Environmental Permitting (England and Wales) Regulations 2016

Application reference: EPR/TP3837MY/V005

Operator: CROWN CHICKEN LIMITED

Facility: Great Westwick Farm Poultry Unit, Marsh Road, BURNHAM-ON-CROUCH, CM0 8NE

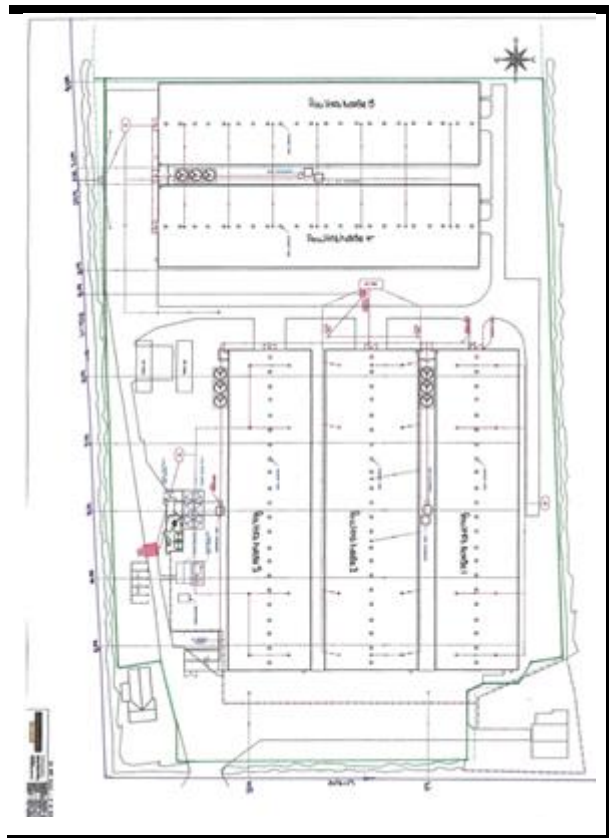
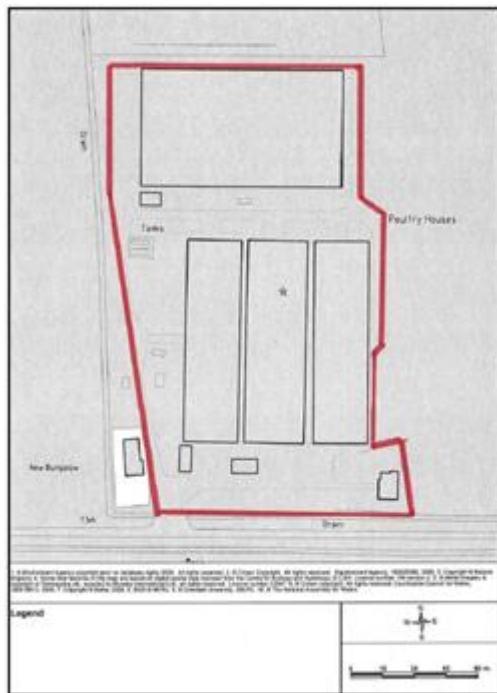
You have requested to remove the property from the south east of the installation boundary via an administrative variation. To do this you need to confirm that no activities associated with the installation have taken place on this area of land. If you can provide any evidence to back this up that would be appreciated. If it has been used for activities associated with the farm it would need to be removed with a partial surrender.

Confirm the property comprises a residential dwelling house with a driveway and garden within the curtilage. Not likely ever been used for rearing any poultry or any directly associated activities. Obtained an image from Google Streetview dated May 2024:
